APPLICATION FOR PERMISSION
UNDER SECTION 16 OF
THE TOWN PLANNING ORDINANCE
(CAP. 131)

For Official Use Only 請勿填寫此欄	Application No. 申請編號	A/YL-KTN/989
	Date Received 收到日期	- 2 FEB 2024

(a) Proposed use(s)/development
擬議用途/發展Proposed Temporary Warehouse (excluding Dangerous Goods Godown)
with Ancillary Facilities for a Period of 3 Years and Filling of Land

S.16 Planning Application No. A/YL-KTN/989

由治河路至申請地點的道路相片：

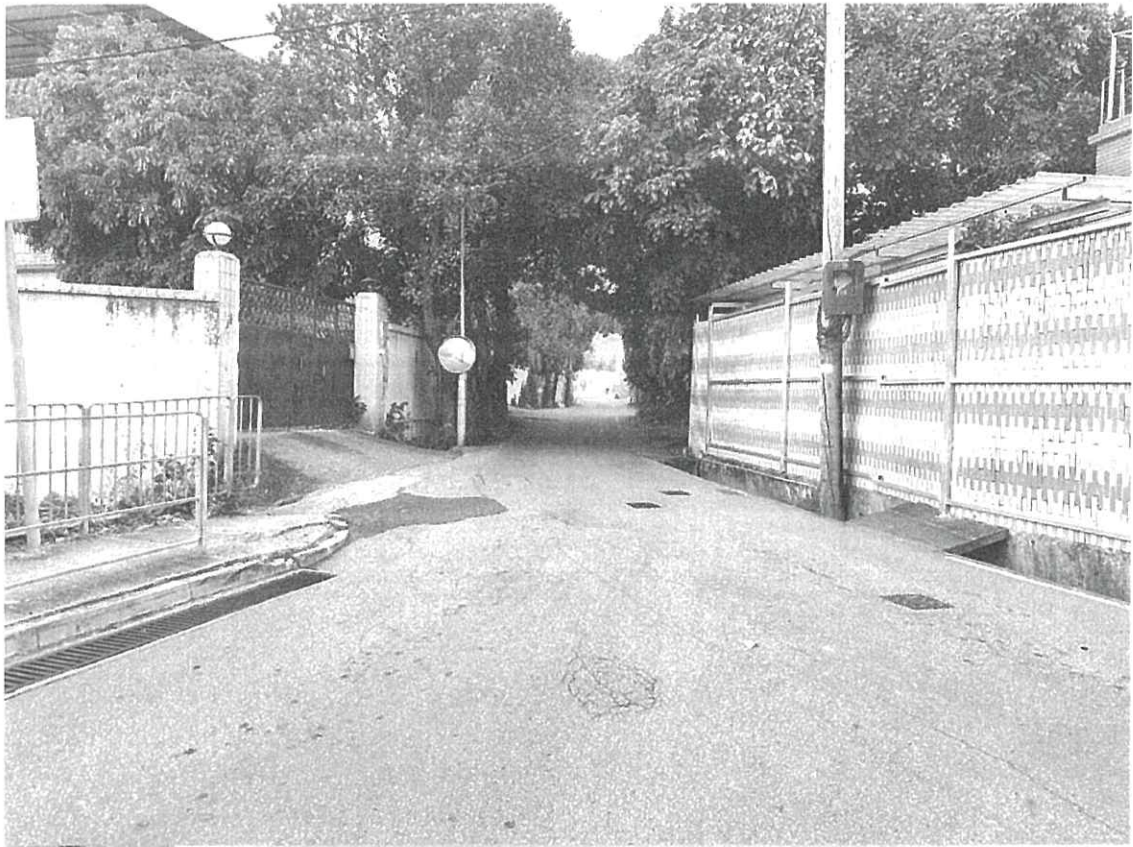
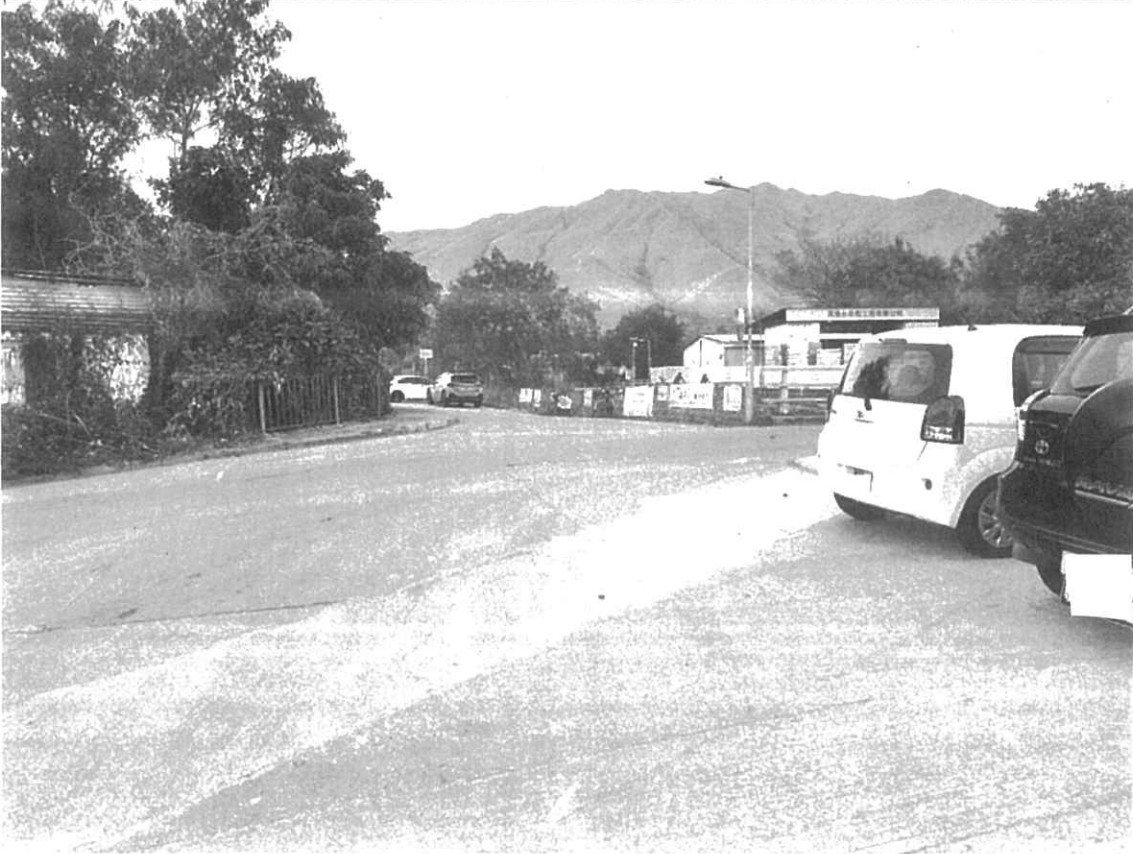
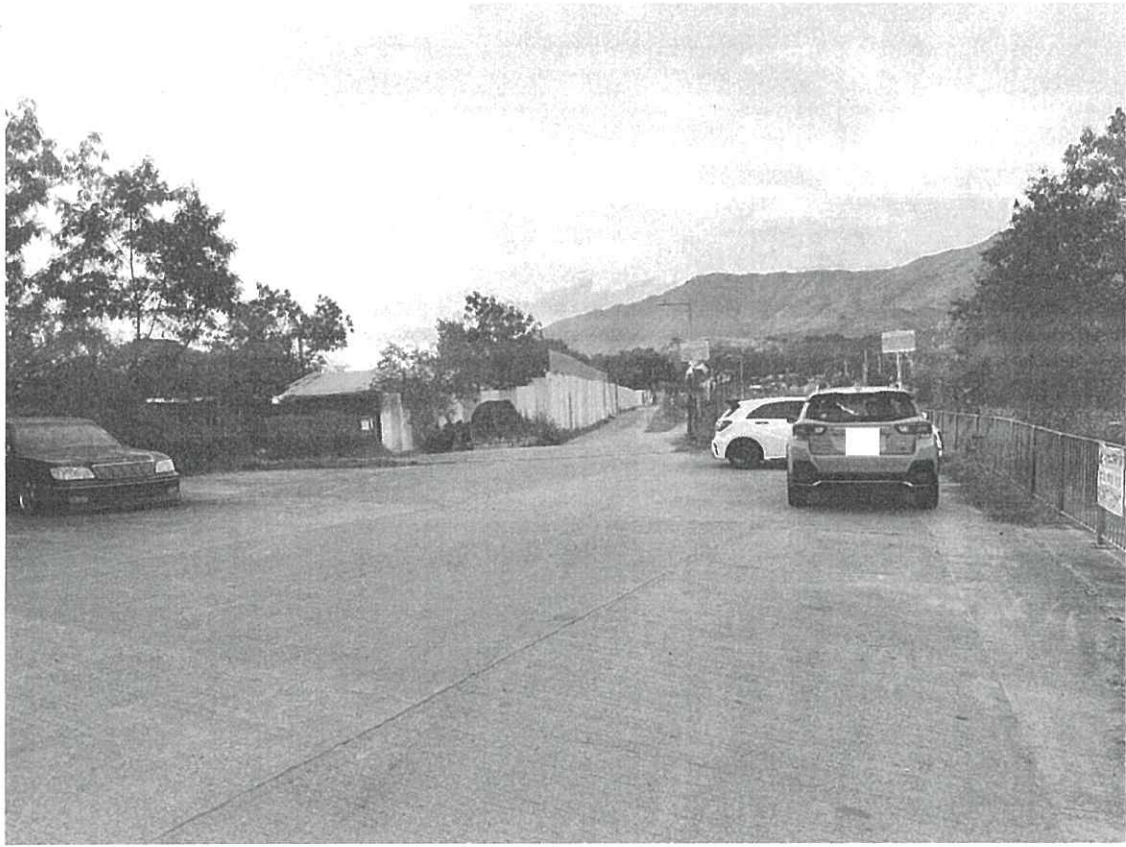
收悉 貴署對 A/YL-KTN/989 申請的意見，本人現書面回覆。

申請地點有道路連接，前往本申請地點途經治河路，再轉到郊區小徑到達申請地點。治河路沿途道路約有 3-6 米闊，並具有避車處。私家及客貨車有足夠的位置通過及進行調遣的動作。申請地點的出入口約 5.5 米闊。沿途道路相片請參考文件末端，而相片的觀看點請參考 Appendix 3。

Appendix 5.1

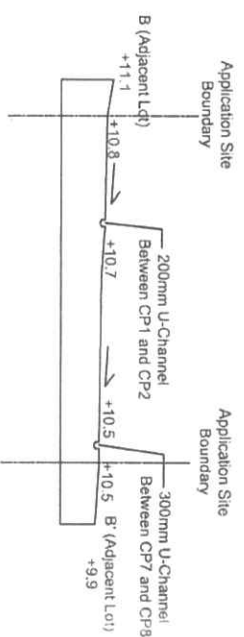
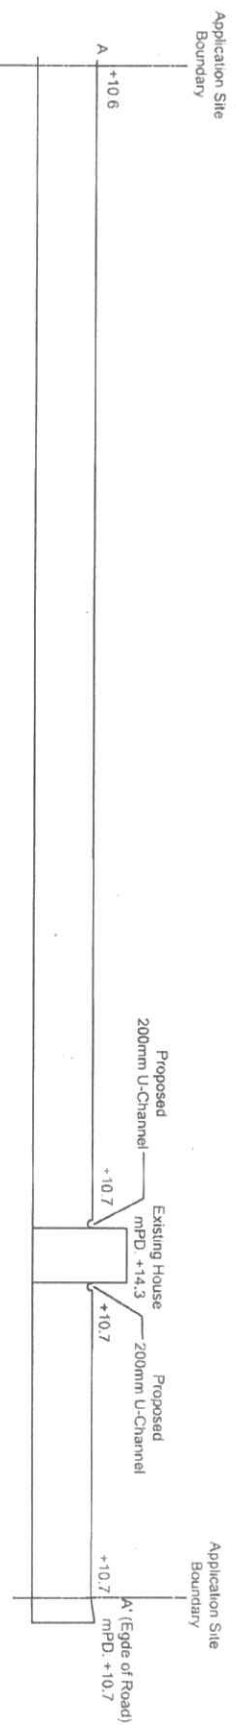
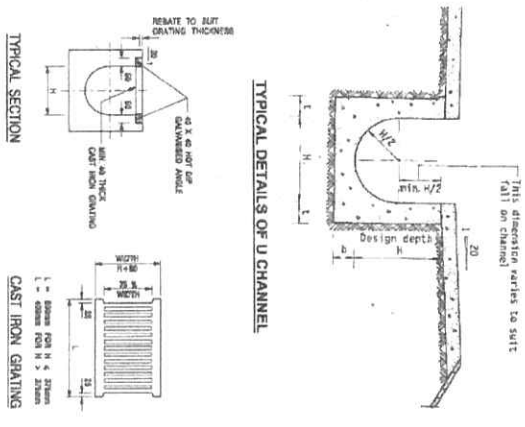
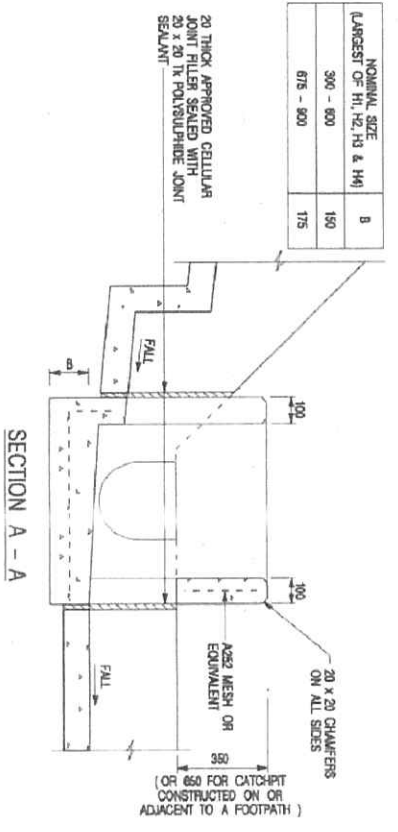
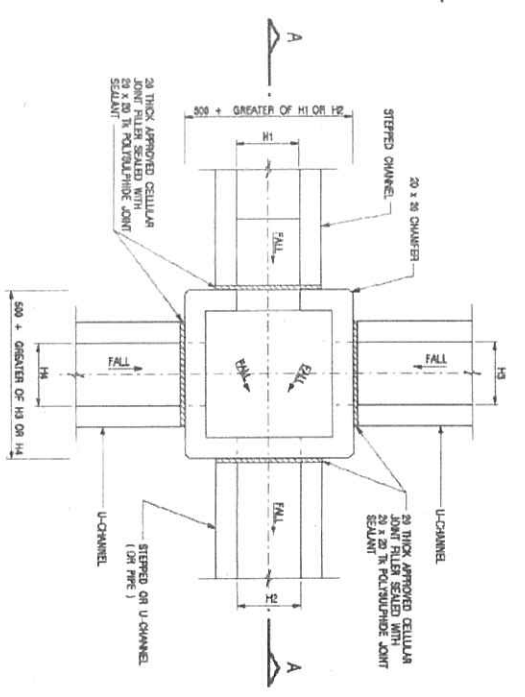
(10)	<i>Please provide more cross sections including adjacent areas for reference. All proposed/ existing drainage facilities should be indicated on section drawings.</i>	請參考 Appendix 5.1。

- xi. the details of cross sections are not correct, such as the size of u-channels. Also, all ground levels included in the Site should be indicated.
